Intersection ID: 16920	Main Street: IDLEWILD_RD	Cross Street: CEDARWILD_RD	Location:	S
ADA ID: 2A3FD26AE7D2	Ramp Type: PerpDiag	Initial Pass/Fail: Fail	Overall Compliance: No	Severity Score: 25

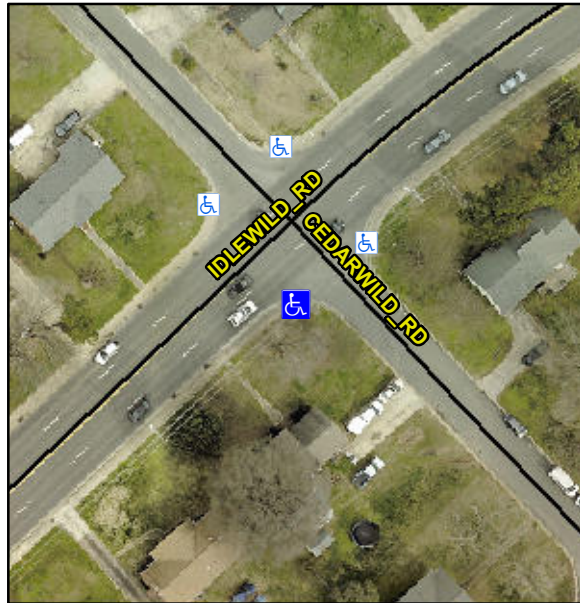
Not Found, R304.2.2, R304.5.3

Remove & Replace Curb Ramp With Two New Directional Ramps or Equivalent.
